**Subject:** Request for Additional Information, dated May 2, 2001  
Sid Larkin & Son, Inc.  
Enterprise Class III Landfill, Pasco County  
Pending Permit Numbers 177982-001-SC and 177982-002-SO

On behalf of Sid Larkin & Son, Inc. (SLS), Hartman & Associates, Inc. (HAI) is submitting for your review, responses to the comments of your request for additional information, dated May 2, 2001, and our meeting on May 10, 2001 for the above referenced facility. Your comments are stated first with our responses following.

**GEOLOGIC CROSS SECTION A - A'**  
**PROPOSED ENTERPRISE RECYCLING AND DISPOSAL FACILITY**  
**DADE CITY, FLORIDA**

**FIGURE 5**

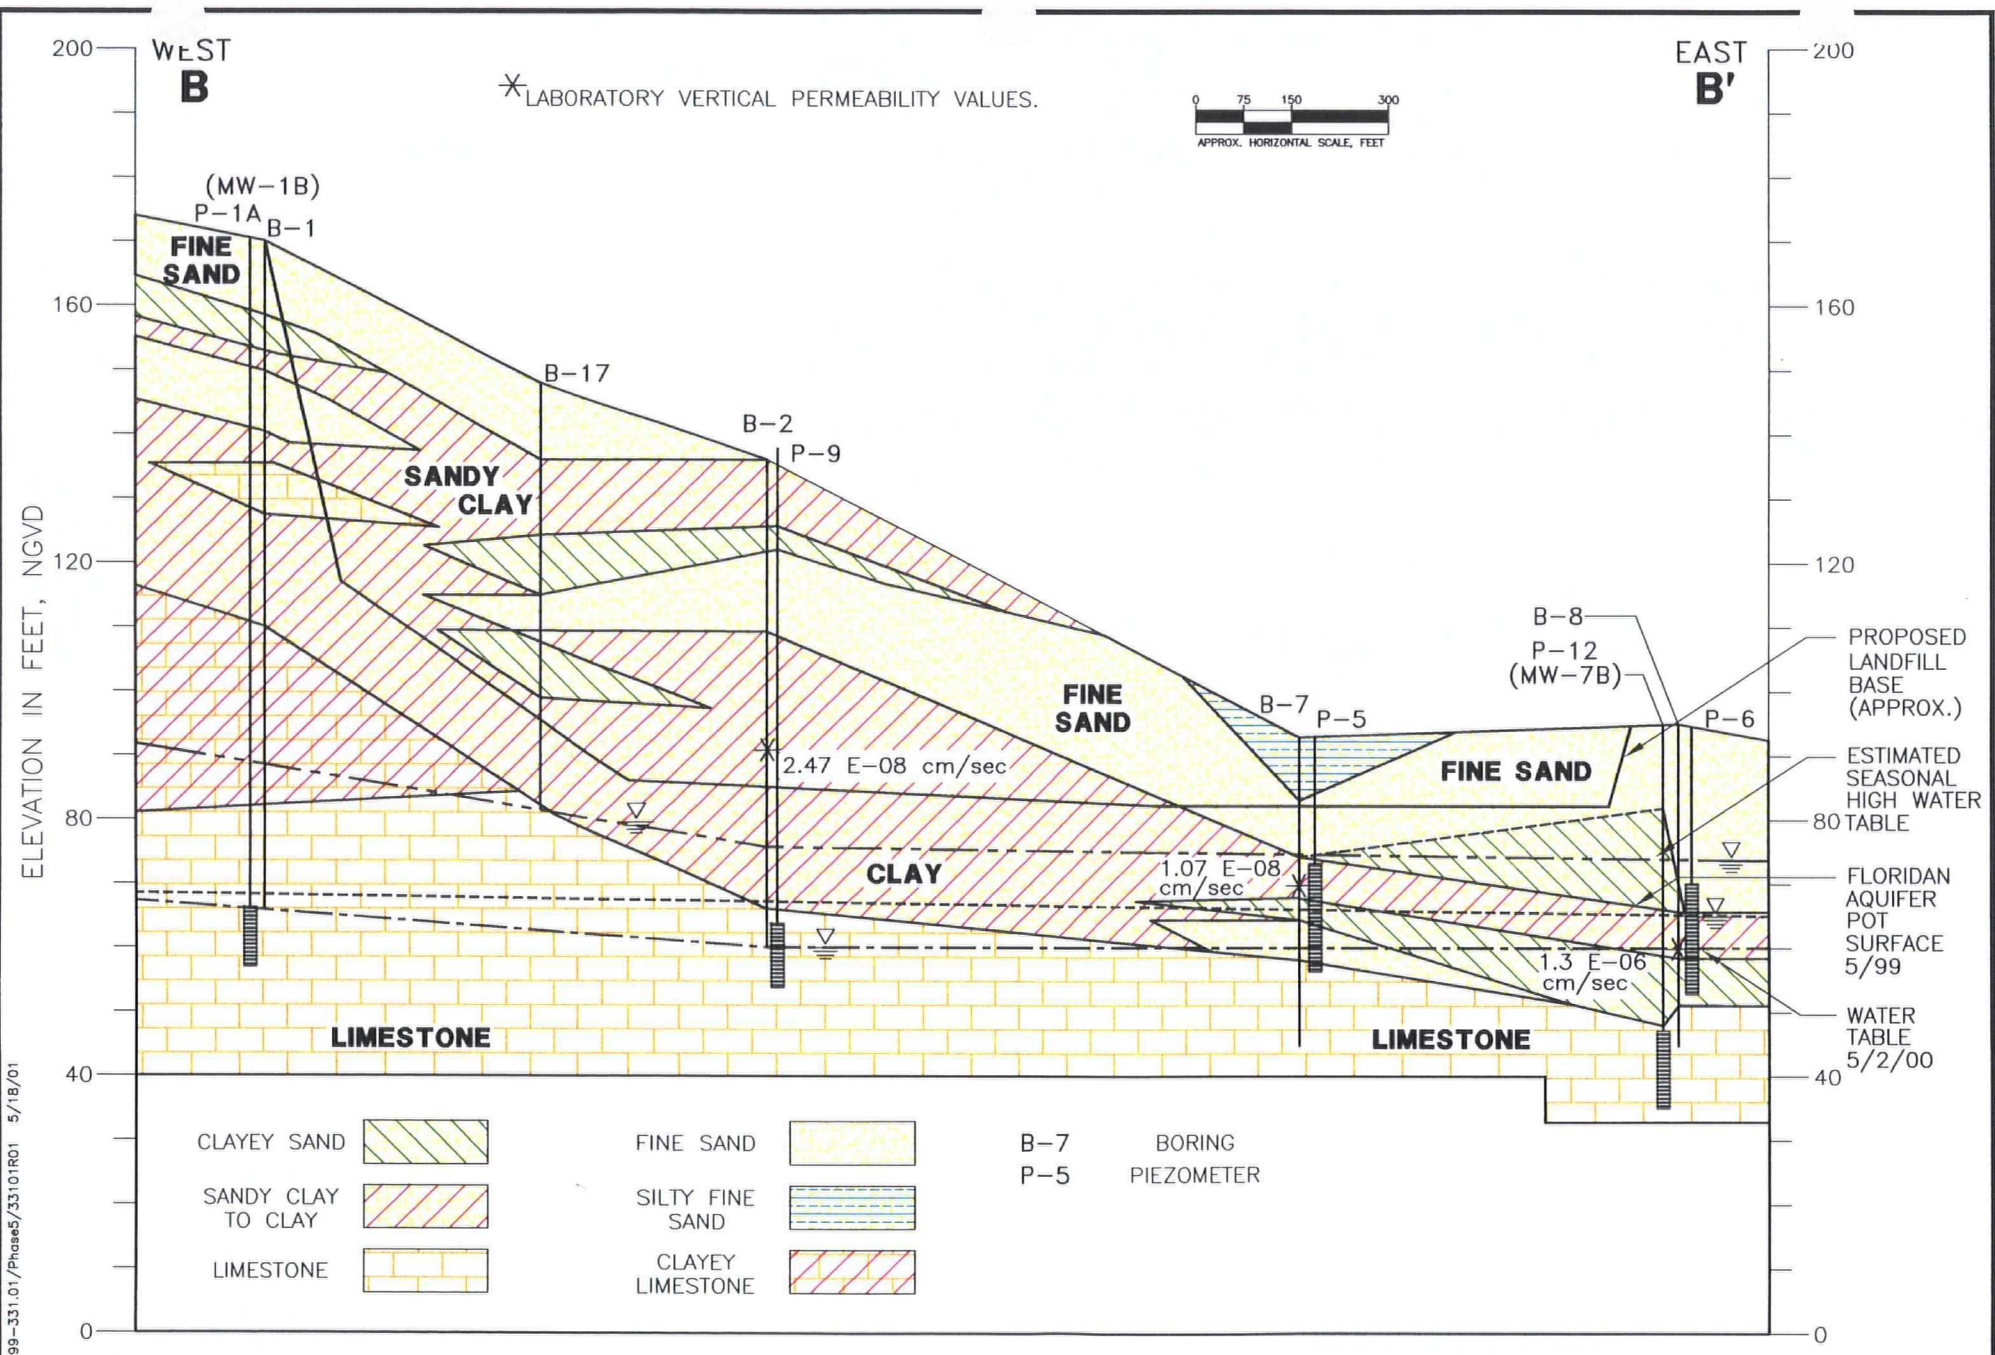
- i. Figure 5 – Please describe the different lithologies reported at adjacent borings L-13 and DCL01-9. (Submittal 2)

**Comment ii.** Figure 5 – Boring log B-7 indicates that clayey sand and slightly clayey sand directly overlie the uppermost limestone deposits. This boring log further indicates that slightly sandy clay is present at least 12 feet above the top of the limestone at B-7. Please discuss the continuity of the sandy clay/clay layer at boring B-7 and adjacent borings DCL01-9/L-13. (Submittal 2).

**Comment iii.** Figure 5 – Please describe the basis for indicating sandy clay/clay deposits are present below the limestone that was encountered at the bottom of boring DCL01-11. (Submittal 2)

**Response:** Borings L-13 and DCL01-9, are not adjacent and are estimated to be separated by at least 50 feet. These borings have similar lithologies, except for the thickness of the "orangish" to "reddish" sandy clay layers encountered. At L-13, there was 20

**Response:** Our boring logs show that the orangish-reddish sandy clay/clay is continuous from borings B-7, DCL01-9 and L-13. At B-7 a 5 ft tan to orange clay layer was encountered at about 73 ft NGVD and grades into sandy clay to a depth of about 64 ft NGVD. Following the rising topography, the orangish sandy clay layer is encountered at DCL01-9 at 80 ft NGVD and again at 85 ft NGVD at L-13. Figure 5 has been revised to more accurately depict this continuous clay unit.

**Response:** In our Figure 5 of submittal 2 we had interpolated between borings B-7 and B-9, where competent limestone was encountered by HAI Geologists. After considering that borings B-1 and DCL01-1 also found limestone above an elevation of 70 ft NGVD, we have revised Figure 5 with limestone below boring DCL01-11.

**FIGURE 6**

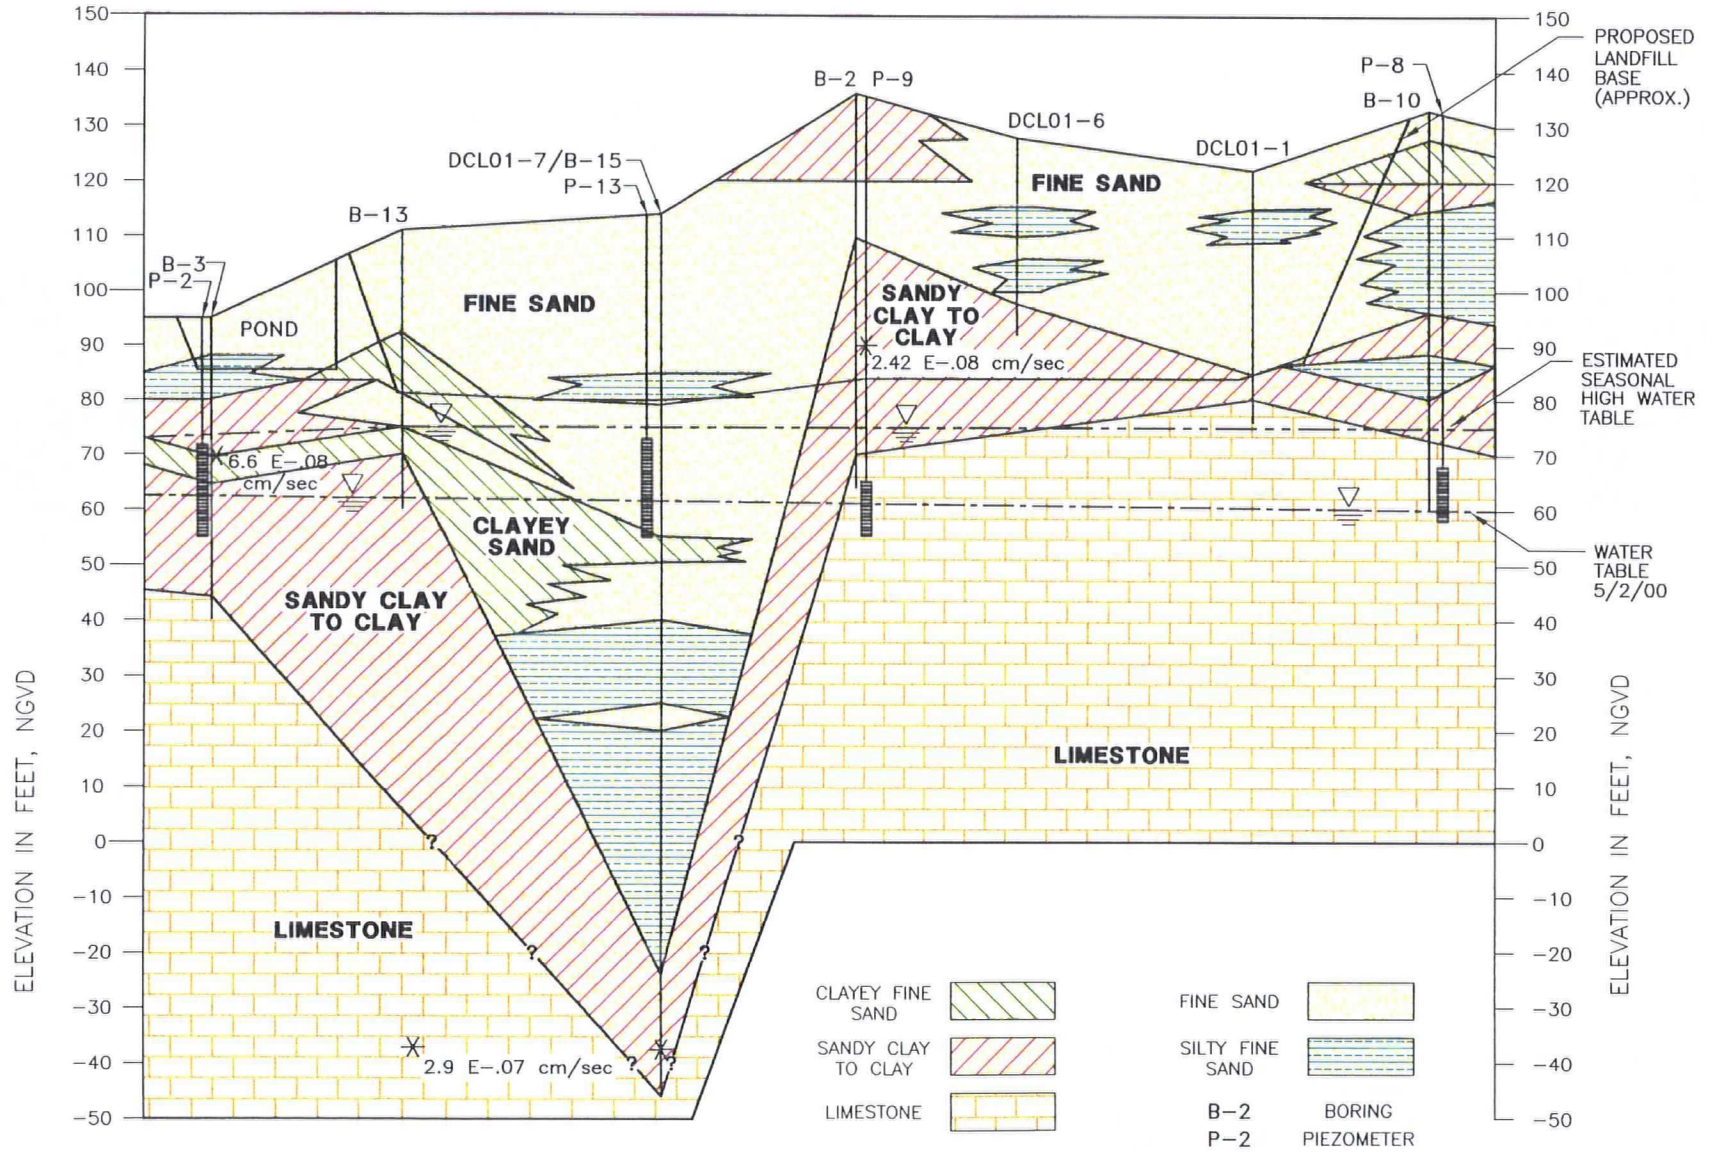
**Comment iv.** Figure 6 – Land surface elevation at boring B-2 is indicated to be about 130 feet, while the boring log and Figure 6.1 appear to indicate the land surface elevation at this location is about 136 feet. Please review and revise as appropriate. (Submittal 2)

**Comment v:** Figure 6 – Boring log B-8 indicates that clayey sand directly overlies the uppermost limestone deposits, and that sandy clay/clay sediments were not encountered. Please discuss the apparent discontinuity of the sandy clay/clay layer in the vicinity of this boring. (Submittal 2)

**Response:** Revised Figure 6 is attached.

**Response:** A close read of boring log for B-8 indicates that clayey sand to a sandy clay was logged at a 30 to 35 foot depth, or from 53 to 63 ft NGVD. A laboratory test sample was collected from 60 ft NGVD at boring B-8, resulting in a confining layer K value of  $1.3 \times 10^{-6}$  cm/sec, see Table 5-2. In addition, a grain size analysis of sample No. 6 at 63 to 61 ft NGVD characterized the sample as a sandy clay with 57% pass 200, see Table 5-3. Therefore, the sandy clay layer is continuous at B-8 and Figure 6 has been revised to more accurately depict this, see attached.

FIGURE  
6.1

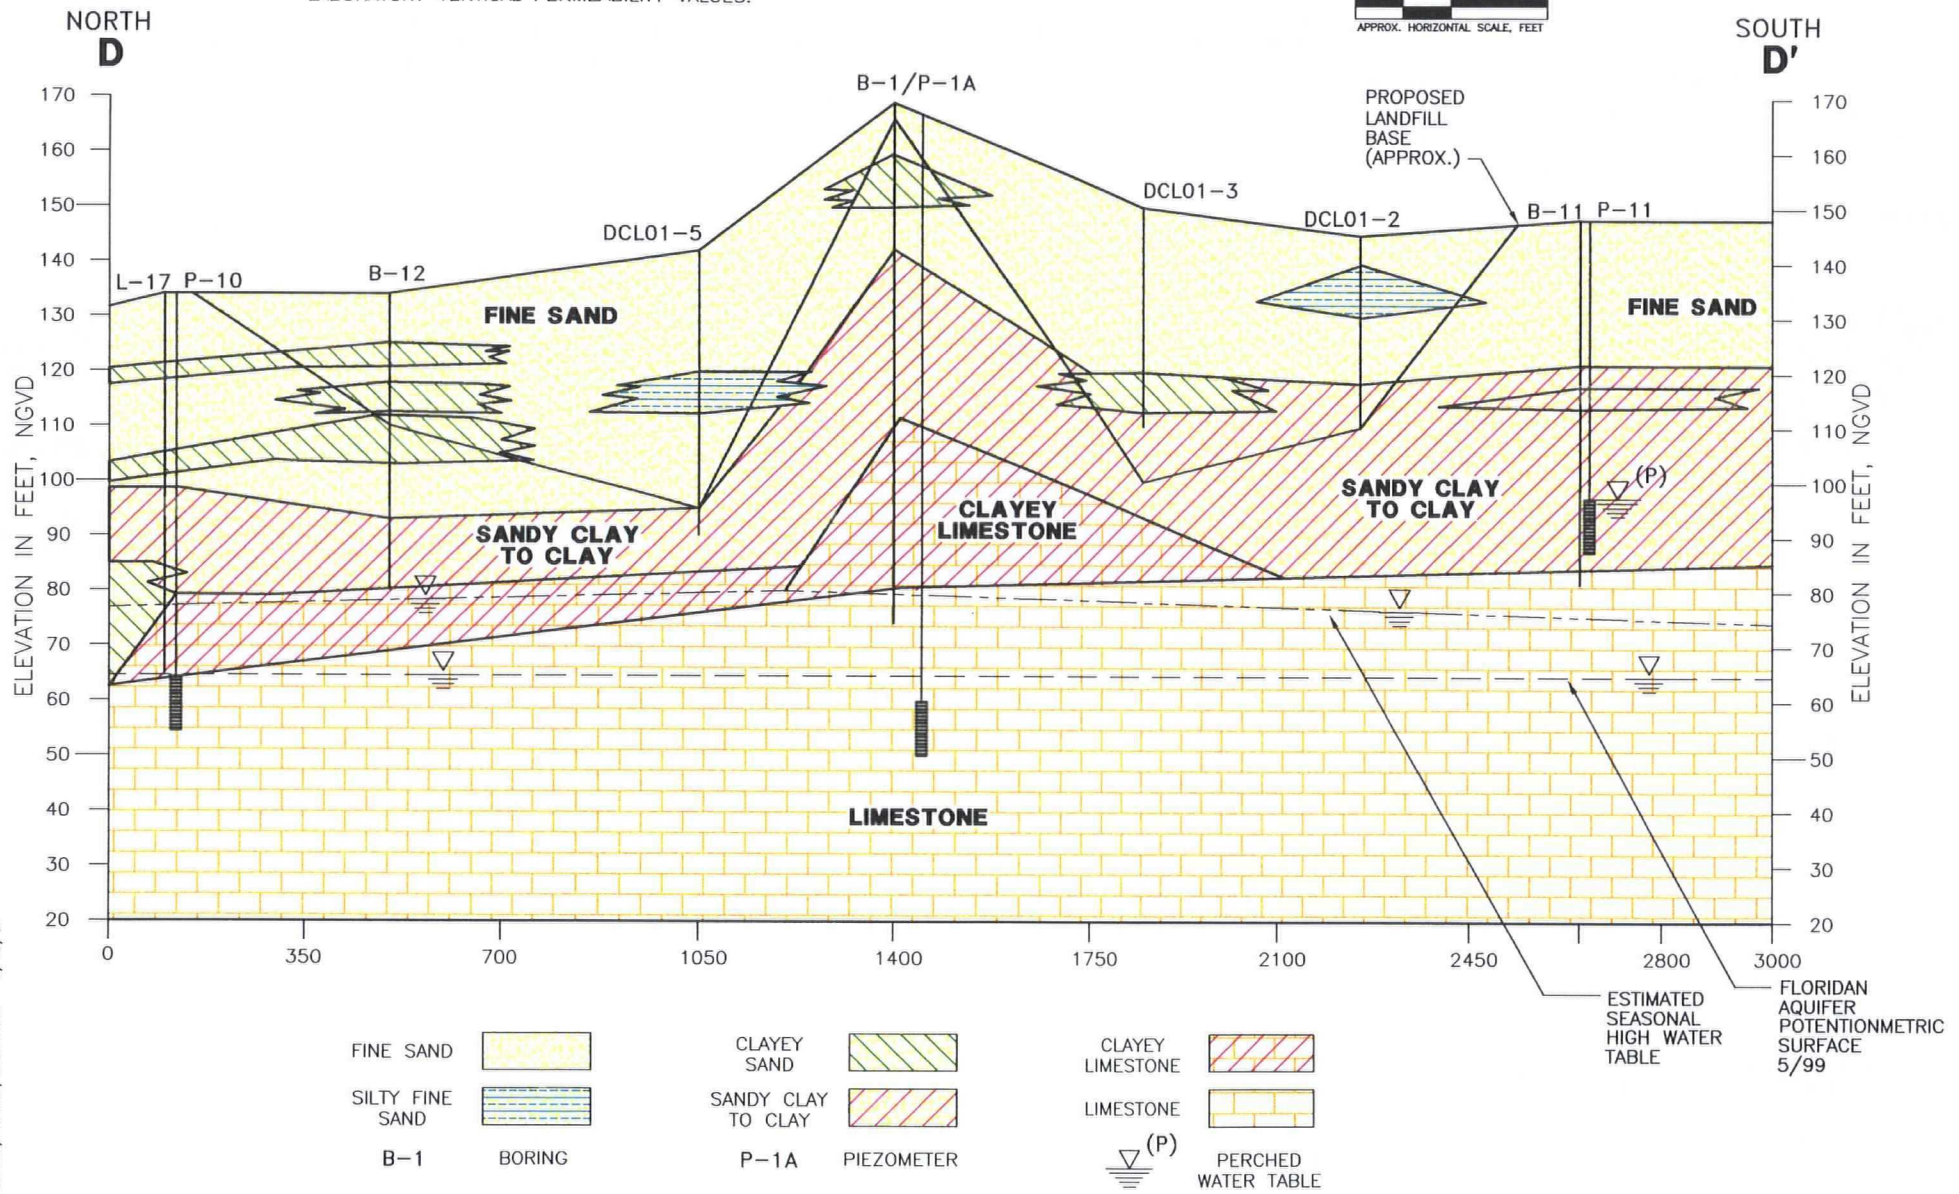
**Comment vi:** Figure 6.1 – Please describe the basis for indicating limestone deposits are present below the sandy clay and clay that were encountered at the bottom of boring B-15. (Submittal 2)

**Comment vii:** Figure 6.1 – Boring log DCL01-1 indicates that the occurrence of sandy silt/clay sediments were limited to the sample collected from 38.5 to 40.5 feet below land surface while the cross section appears to indicate a thickness of about 15 feet of sandy clay/clay sediments overlying the uppermost limestone deposits. Please review and revise as appropriate. (Submittal 2)

**Comment viii:** Figure 6.1 – Please discuss what steps will be implemented in the vicinity of boring DCL01-1 to ensure the sandy clay/clay layer will not be breached during excavation to the design depth. It appears that the base of the excavation will be within about five feet of the uppermost limestone deposits at this location. (Submittal 2)

**Response:** Our basis was a geologist's interpolation of the limestone contact between borings B-3 and B-2, with allowance for the depression at B-15. Also, the overlying sandy clay has typically been about 20 feet thick over the limestone. The figure has been revised to show a dashed line to indicate our interpolation.

**Response:** Figure 6.1 has been revised to depict a 5-foot sandy clay layer from 84 ft to 79 ft NGVD.

**Response:** The following procedures will be implemented to ensure that the sandy clay layer at DCL01-1 (Cell 6/Cell 3) will not be breached:

1. Implement new cell certification procedures in Section 3.15 of the Engineering Report and Operations Plan.
2. Set a surveyed benchmark near each new cell during mining operations to be used by Operator to shoot periodic grades to ensure that excavation does not go below the design base elevation of 82 ft NGVD.
